PAR Change for P802.3bt

Proposed change

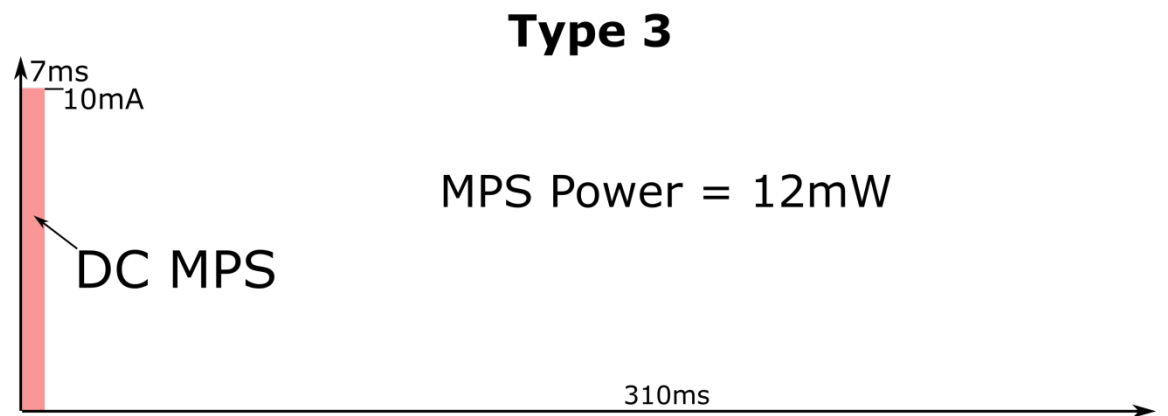
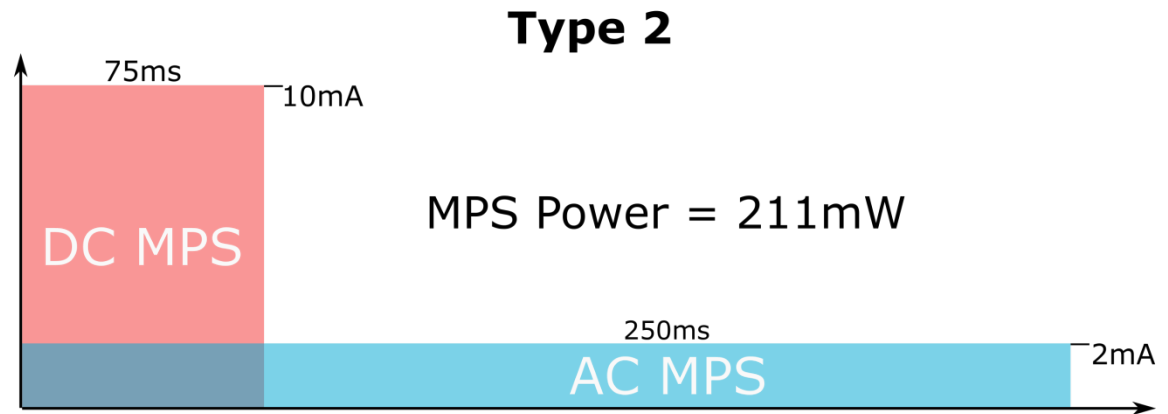
- 802.3bt is creating two new Types (PSE & PD)
 - **Type 3** allows **60W** PSE power
 - **Type 4** allows **90W** PSE power
- New features have been added to these new Types that also provide benefit for 2-pair systems at power levels addressed by Type 1 (802.3af) and Type 2 (802.3at)
- Type 3 PSEs are allowed to operate over 2P only with maximum power of 30W and provide these new features. This requires a PAR change.

5.2.b. Scope of the project: The scope of this project is to augment the capabilities of the IEEE Std 802.3 standard with 4-pair power and associated power management information. The project will augment the methodology for the provision of power via balanced cabling to connected Data Terminal Equipment with 802.3 interfaces. Optional augmented power limit will be made available for certain structured cabling systems. **Improvements, precluding raising the power limit, introduced for 4-pair systems may be enabled for 2-pair systems.** Compatibility with existing equipment will be maintained.
